# SERVICE BULLETIN

No. 216

Piper Aircraft Corporation

SUBJECT: Fuel Cell Drain Modification  
MODELS AFFECTED: PA-24 and PA-24 "250" Comanches. Serial Numbers 24-581 to 24-3495 inclusive.  
COMPLIANCE DATE: Prior to completion of the next 25 hours of operation

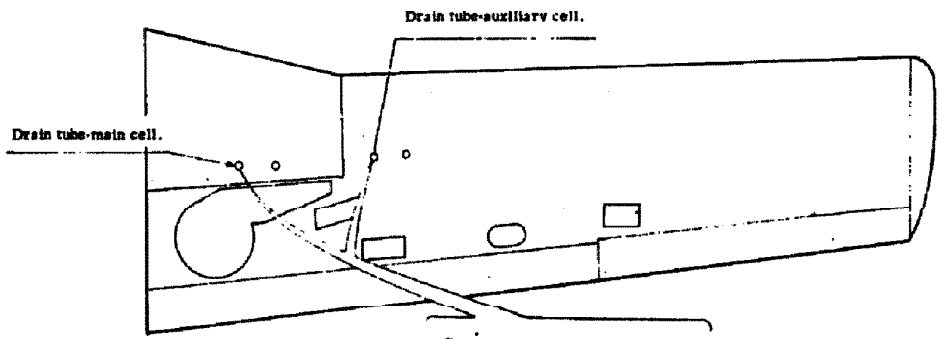
Reports of fuel cell collapse in the Comanche have been received from the field. This collapse is basically due to loose fuel cell caps and a negative pressure in the fuel filler neck area created by the rearward scarf on the fuel filler neck drain tube.

Kit 756 756 has been developed to change this negative pressure to a positive pressure by facing the scarf forward.

PA-24 and PA-24 "250" Comanches, serial numbers 24-581 to 24-1197 inclusive, have a 1-4" fuel drain line and serial numbers 24-1198 to 24-3495 inclusive have a 1-2" fuel drain line. Kit 756 756 is adaptable to both types. See sketch below this bulletin.

Tube 1/4", Serial No. 24-581 to 24-1197  
 size 1/2", Serial No. 24-1198 to 24-3495

Gasket 24353-02

Adapter 24353-03
